BARANOF WARM SPRINGS HARBOR IMPROVEMENTS

PROJECT No. 68353 RE-BID

Record Drawings have been reviewed by the Project Engineer, and represent to the best of my knowledge, the project as constructed.

PILE DATA & DETAILS

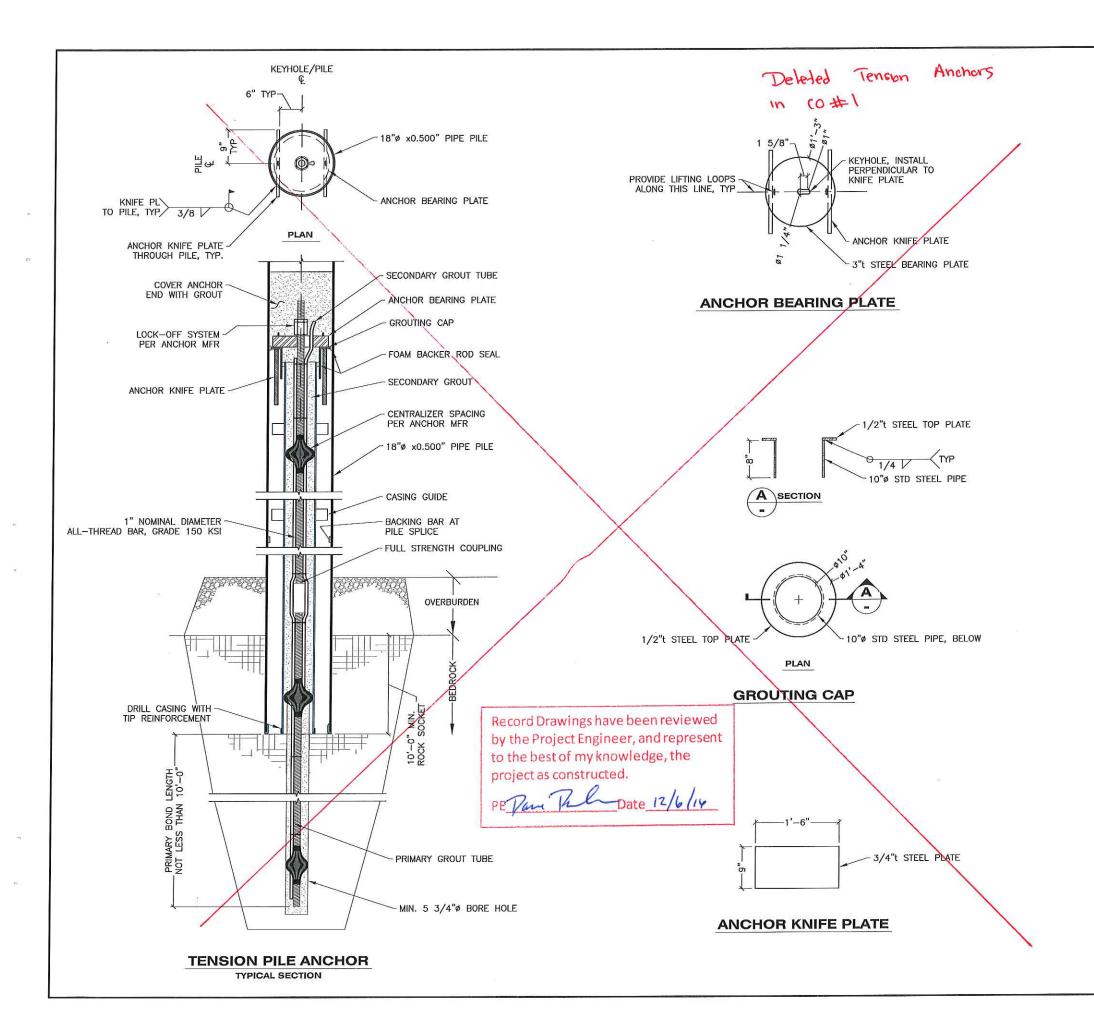
not installed tension anchors

Ples were embedded ~ 26.ft. Contractor conducted pull test to verify each pile met the required sorp uplat capacity > Encountered abstruction @ 18 ft bgs. Pile advanced to 17.5 w/ a 1" bearing plate welded to the bottom. 186 KIP bearing capacity.

ANODE BRACELET DETAIL

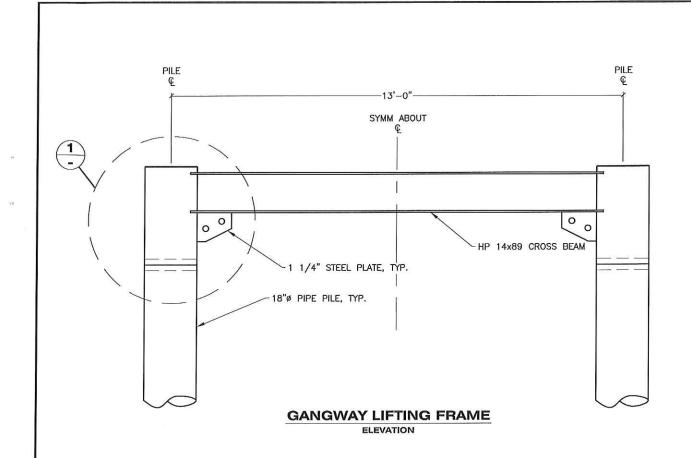
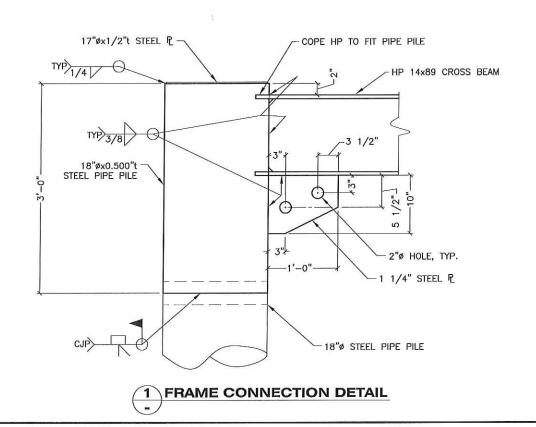
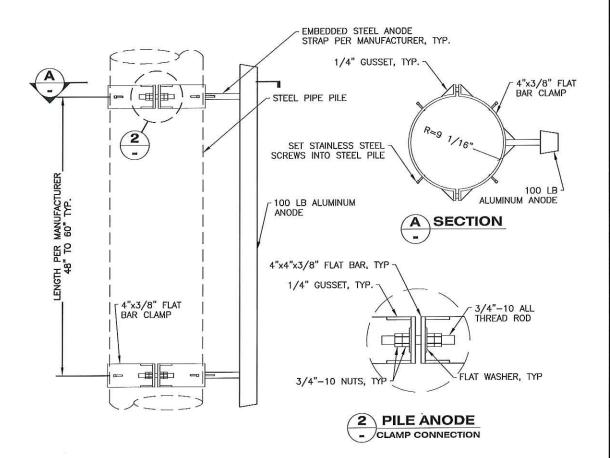
ode bracelets used on piles 364 ly. Remaining anodes were welded 49th
